SUBJECT: CERTIFICATION OF THE MINUTES OF THE ACRS APR1400
 SUBCOMMITTEE ON SEPTEMBER 21-22, 2016, ROCKVILLE,
 MARYLAND

SUBJECT: CERTIFIED MINUTES OF THE ACRS APR1400 SUBCOMMITTEE
MEETING ON SEPTEMBER 21-22, 2016

ADVISORY COMMITTEE ON REACTOR SAFEGUARDS
MINUTES OF THE APR1400 SUBCOMMITTEE MEETING ON
SEPTEMBER 21-22, 2016, ROCKVILLE, MD

Figure 2.0-1 Horizontal Certified Seismic Design Response Spectra

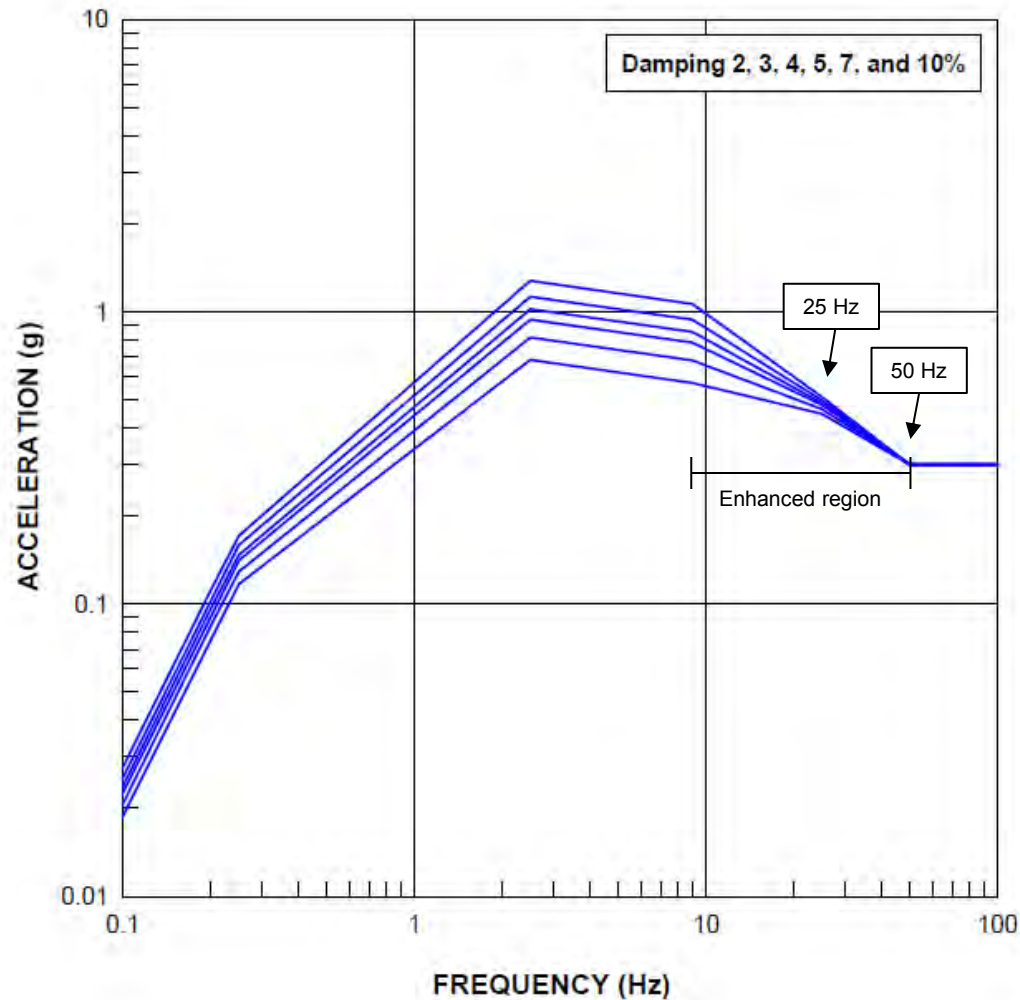
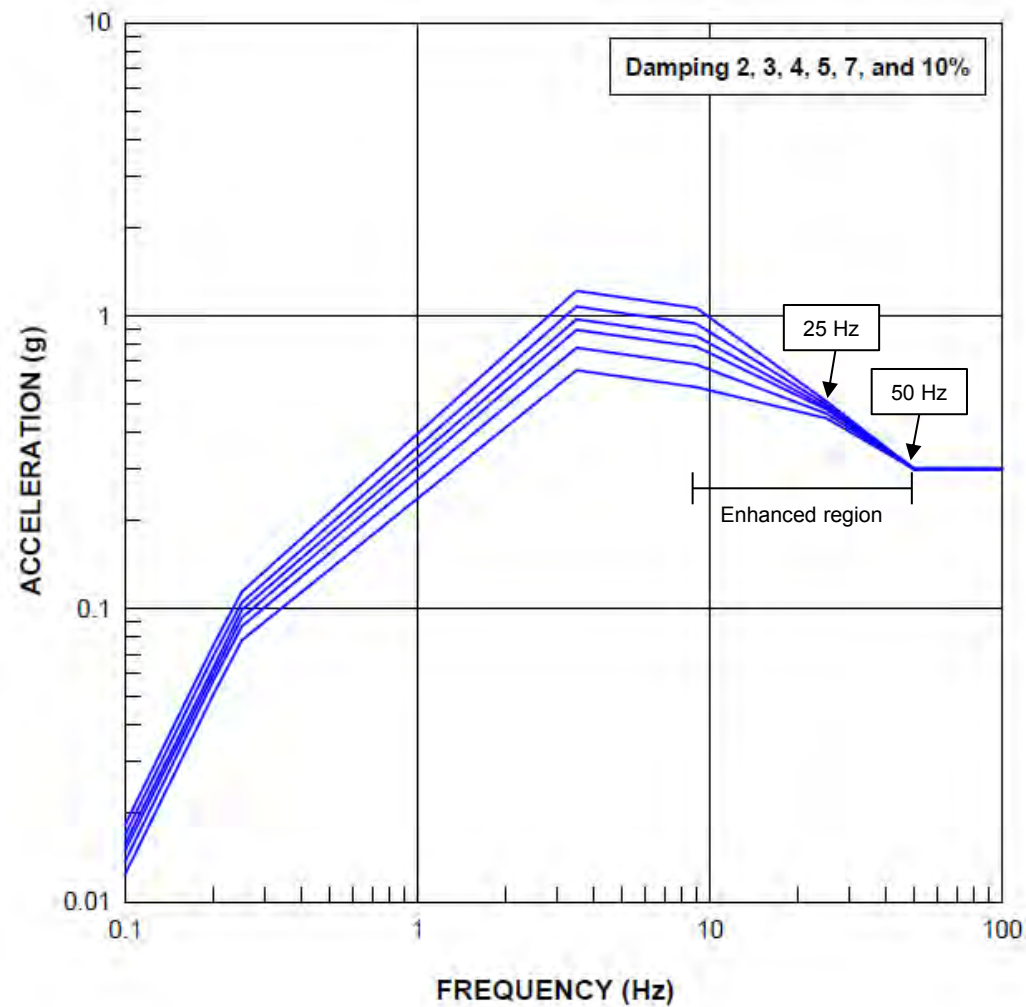
Mr. Koh presented DCD Section 2.5 that describes geology, seismology, and geotechnical engineering. He discussed how various response spectra are developed/used. KHNP to fix DCD Tier 2 Figures 2.0-1 and 2.0-2 (Tier 1 Figure 2.1-1 and 2.1-2) for certified seismic design response spectra by labeling the damping values.	43-46 Slides 14-18

15 CHAIRMAN BALLINGER: With respect to
16 this Figure 2.0.1 and 2, by the way, in the DCD
17 nothing is labeled. This figure is clearer but --
18 and I guess we can guess what damping 2, 3, 4, 5,
19 7, and 10 percent are, but in the DCD there's no
20 labels at all that tells you anything. So you
21 probably ought to think about fixing that.

9 MR. KOH: Damping labels will be added
10 to here.
